277-289 WOODPARK ROAD SMITHFIELD NSW 2164

CIVIL WORKS

AMENDED PLAN

ALS
SMITHFIELD REDEVELOPMENT APPLICATION
277-289 WOODPARK ROAD SMITHFIELD LOT 1 IN DP1024505
COVER SHEET, DRAWING LIST
AND LOCALITY PLAN
CALIBRE DRG No.
COPP20170-DWG-C-0000
CLIENT DRG No.

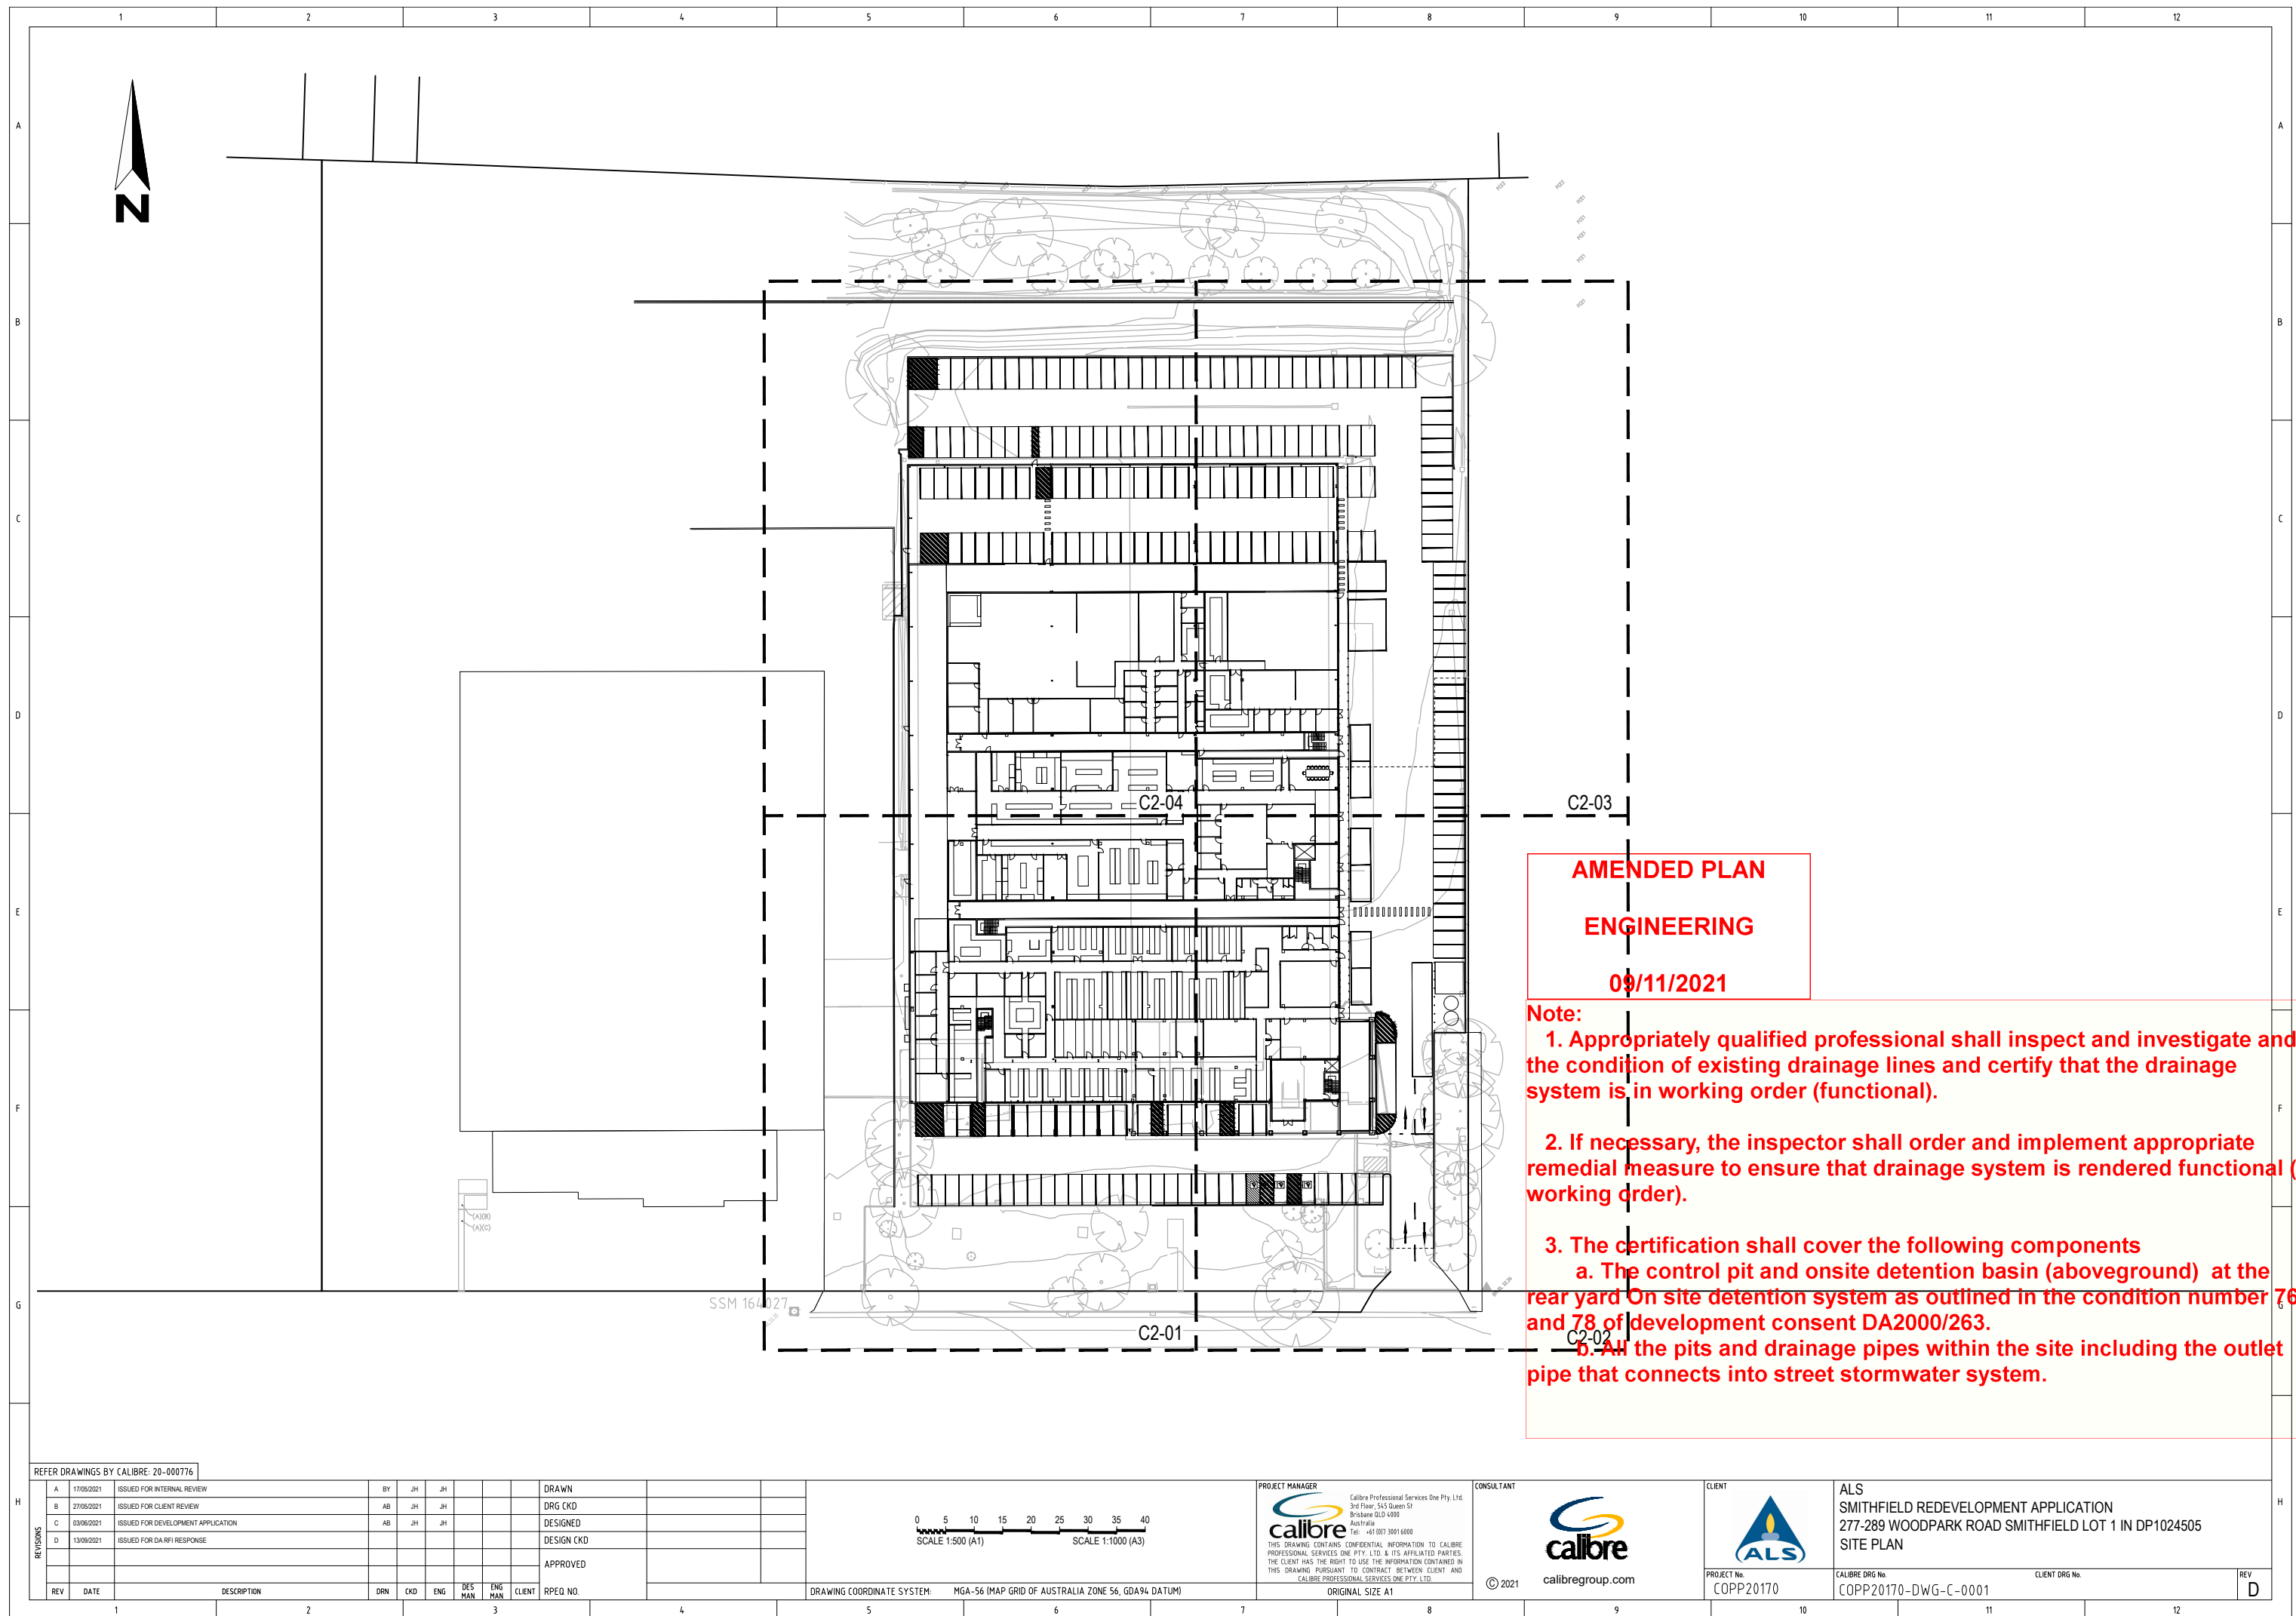
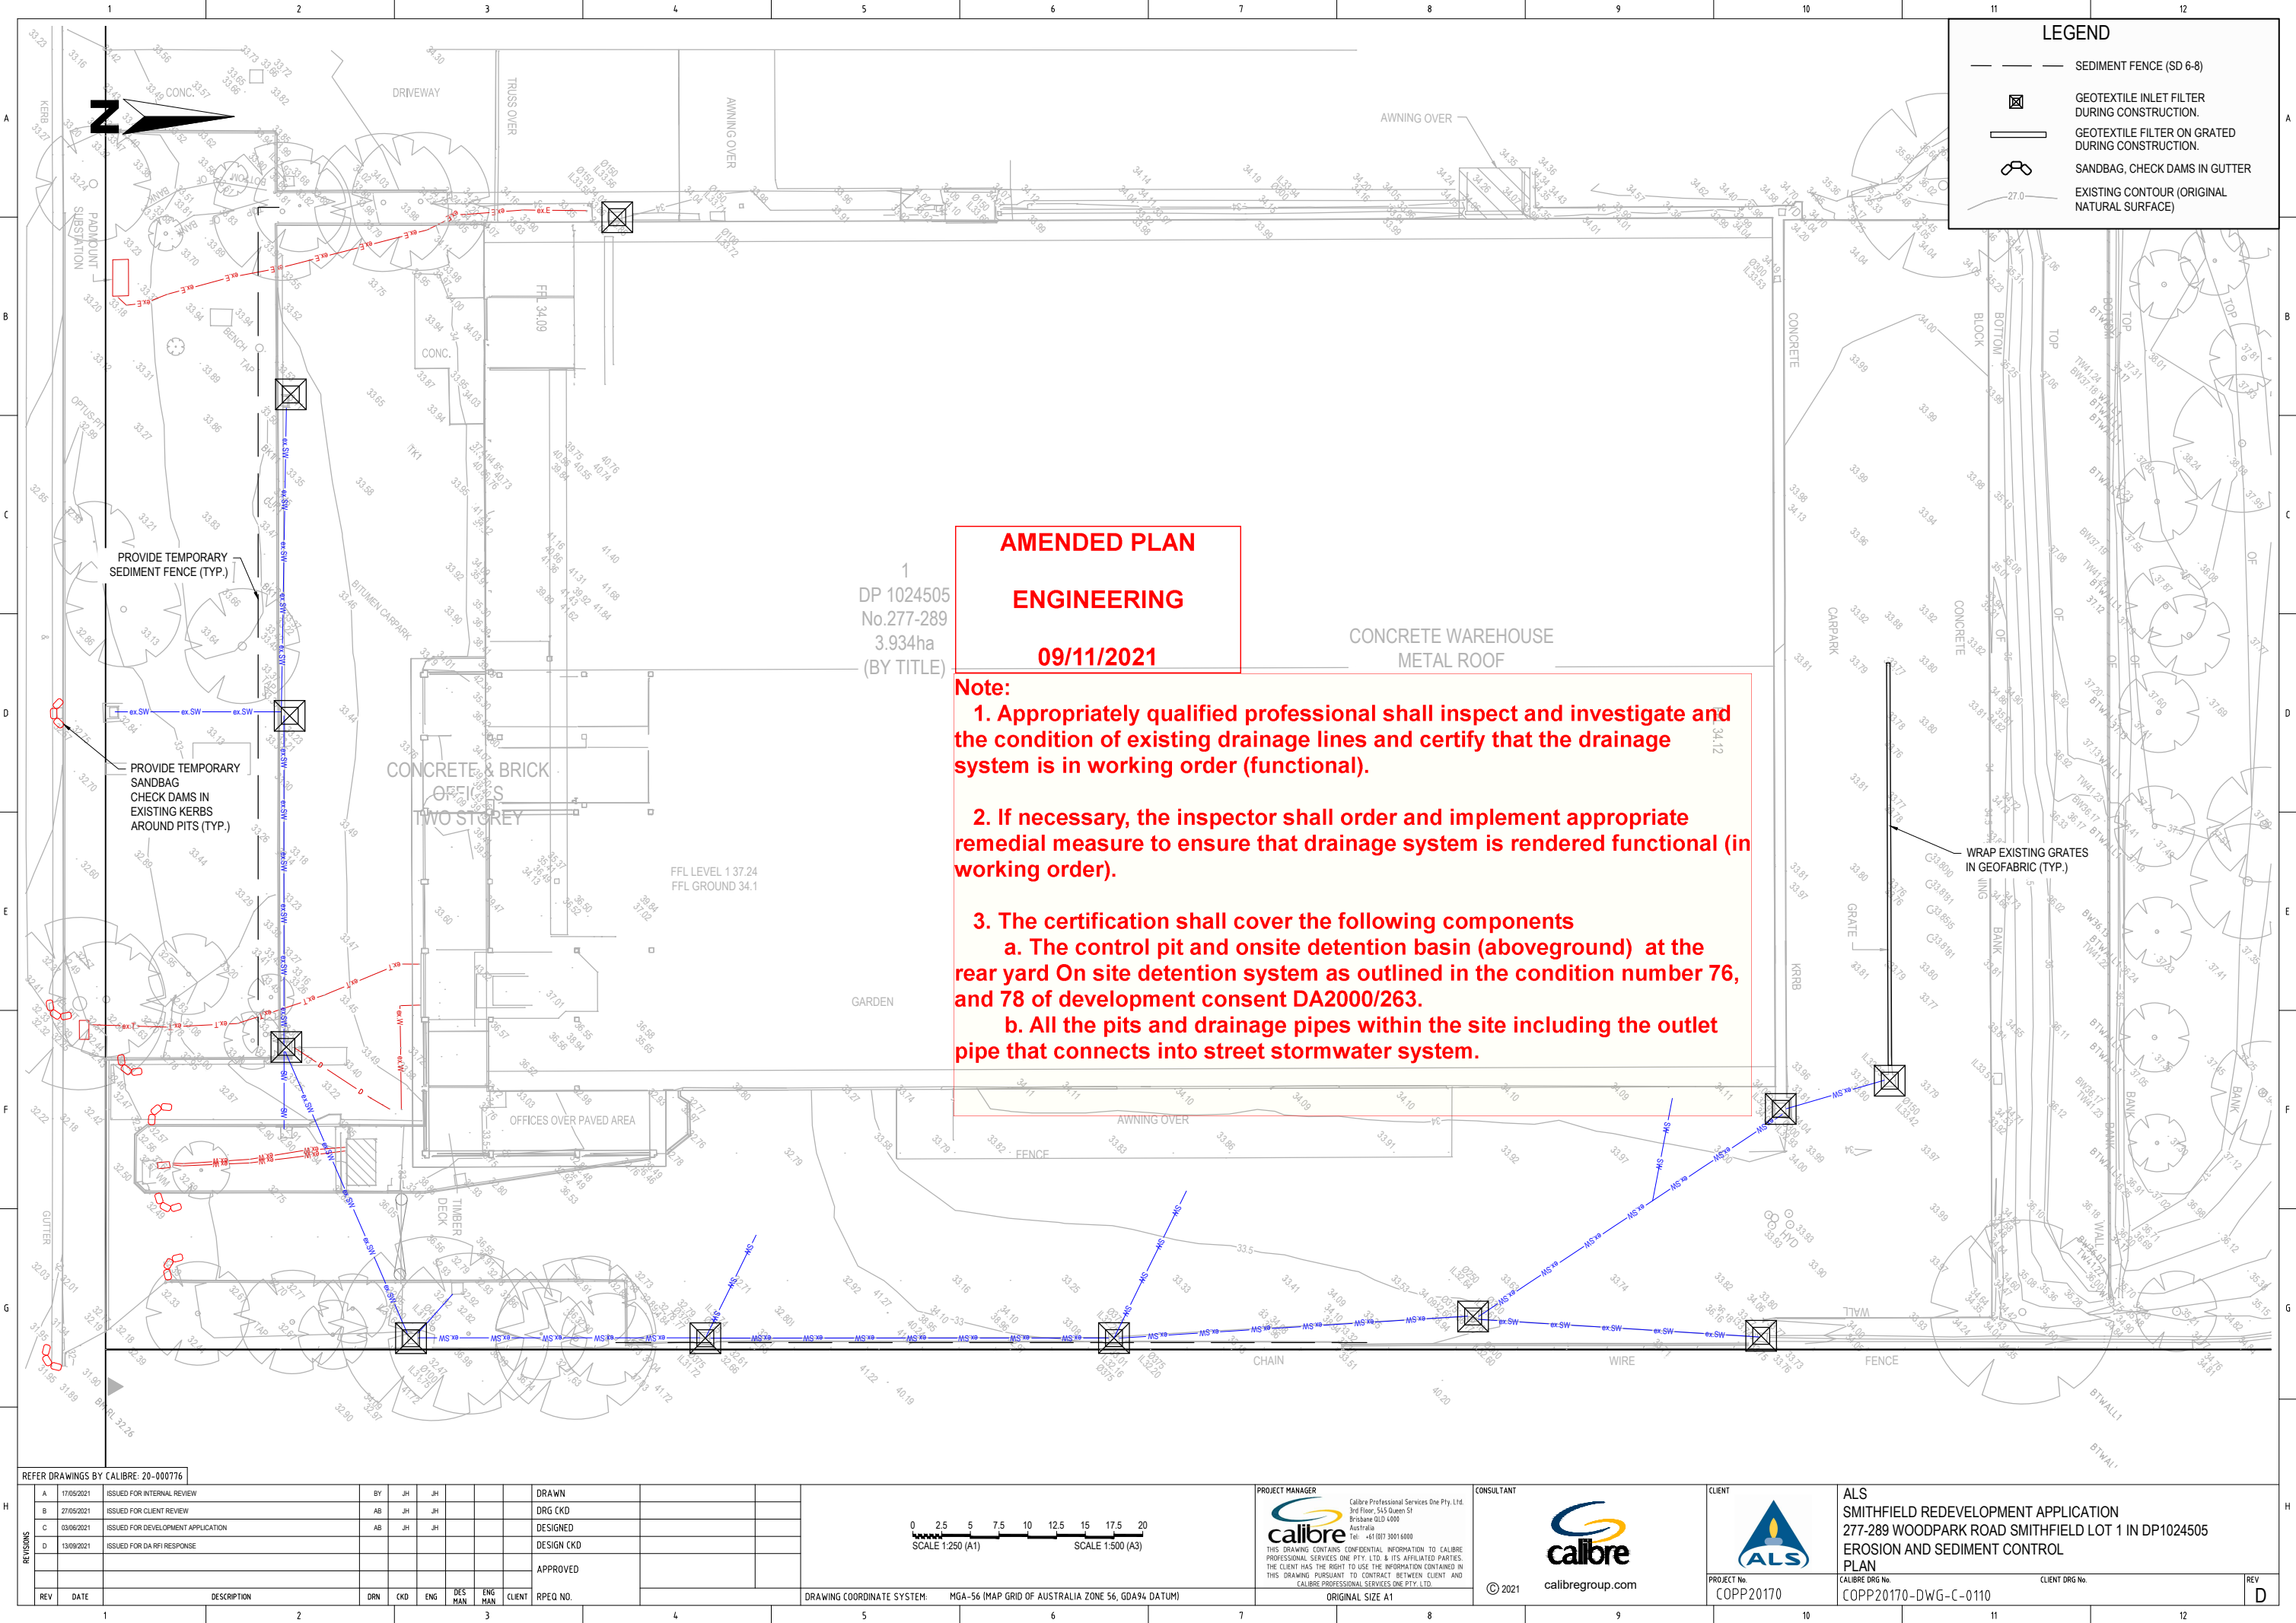
1. Appropriately qualified professional shall inspect and investigate and the condition of existing drainage lines and certify that the drainage system is in working order (functional).
2. If necessary, the inspector shall order and implement appropriate remedial measure to ensure that drainage system is rendered functional (in working order).
3. The certification shall cover the following components
 - a. The control pit and onsite detention basin (aboveground) at the rear yard On site detention system as outlined in the condition number 76, and 78 of development consent DA2000/263.
 - b. All the pits and drainage pipes within the site including the outlet pipe that connects into street stormwater system.

- Note:**
1. Appropriately qualified professional shall inspect and investigate and the condition of existing drainage lines and certify that the drainage system is in working order (functional).
 2. If necessary, the inspector shall order and implement appropriate remedial measure to ensure that drainage system is rendered functional (in working order).
 3. The certification shall cover the following components
 - a. The control pit and onsite detention basin (aboveground) at the rear yard On site detention system as outlined in the condition number 76, and 78 of development consent DA2000/263.
 - b. All the pits and drainage pipes within the site including the outlet pipe that connects into street stormwater system.
